SUNLIGHT  
PROPERTIES  
LLC

JEFFERSON/SILVER  
TOWNHOMES

SITE PLAN & TCL

#### SITE PLAN

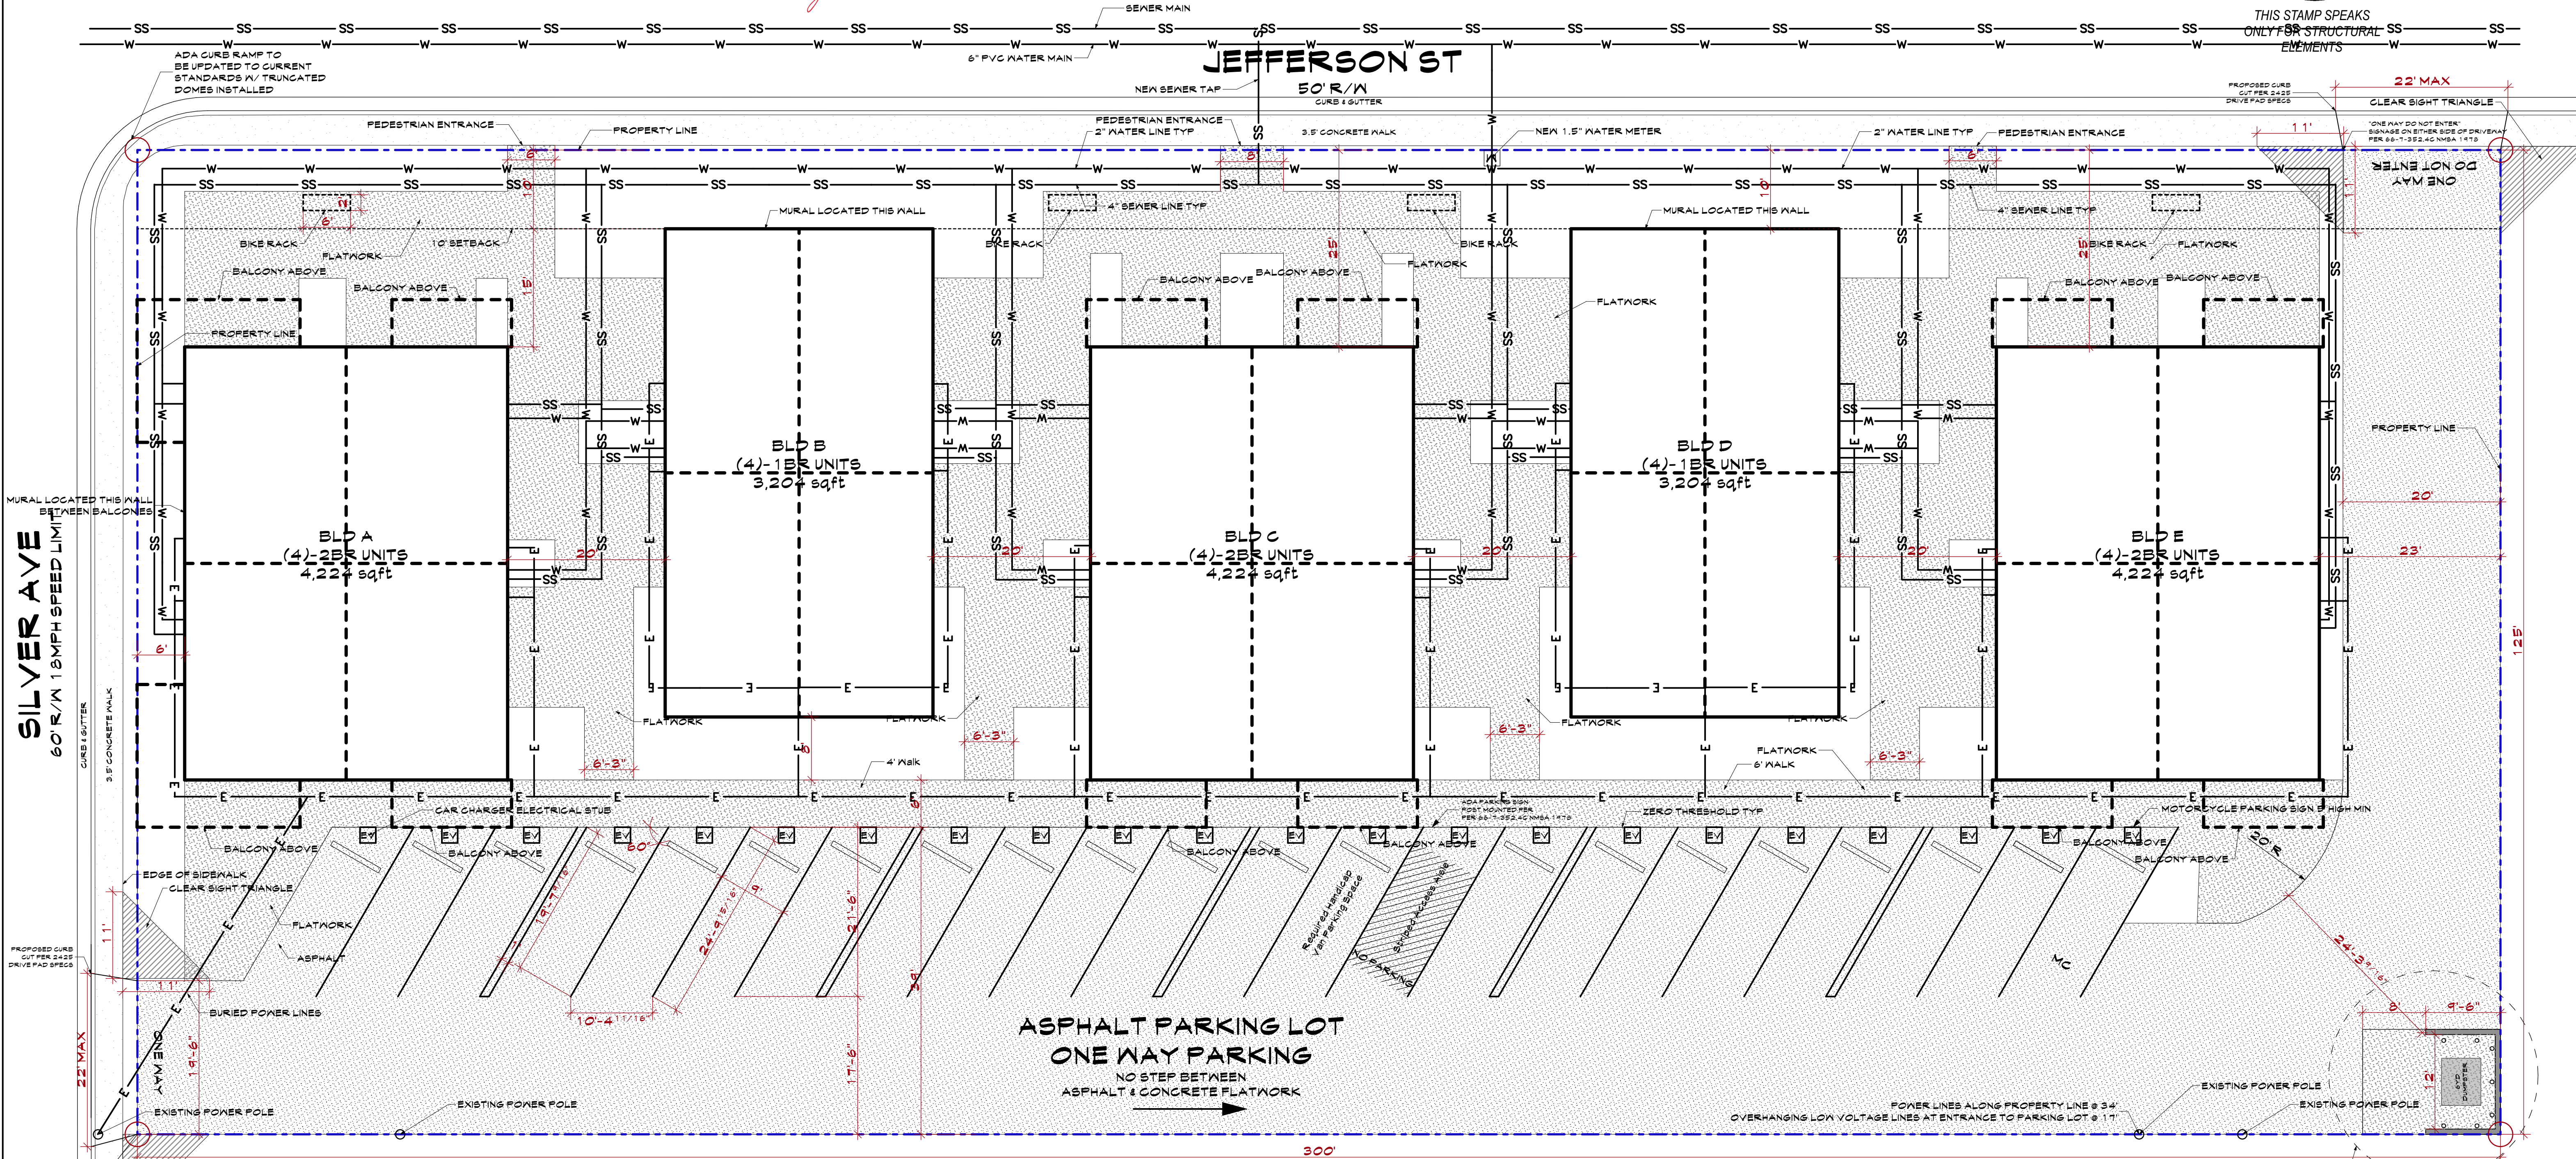
APPROVED FOR ACCESS  
ONLY SOLID WASTE DEPT  
NO DEDICATED SPOT FOR RECYCLING  
1-SINGLE TRASH ENCLOSURE-11-03-2022
